Customer Notification

B-CN-444-EN REV A

SUBJECT: TT/TG Series Rubber Mount Dimensions

Figure 1 – TT/TG Series Compressor Rubber Mount

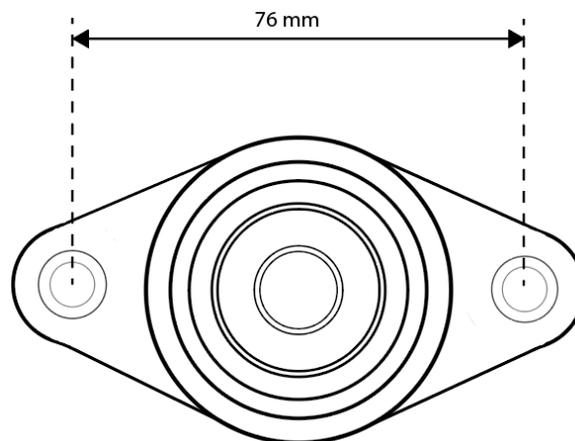
The purpose of this bulletin is to inform our customers that there was a discrepancy in the measurement between the distance of the mounting holes for our TT/TG Series Compressor Rubber Mounts. Our previous documentation showed a distance of 76.2 mm between the mounting holes for the compressor mount. The actual distance is 76 mm. All compressor mounts shipping out from our factories will have a measurement of 76 mm (refer to Figure 1 below).

Continue to order part number 100066 as required.
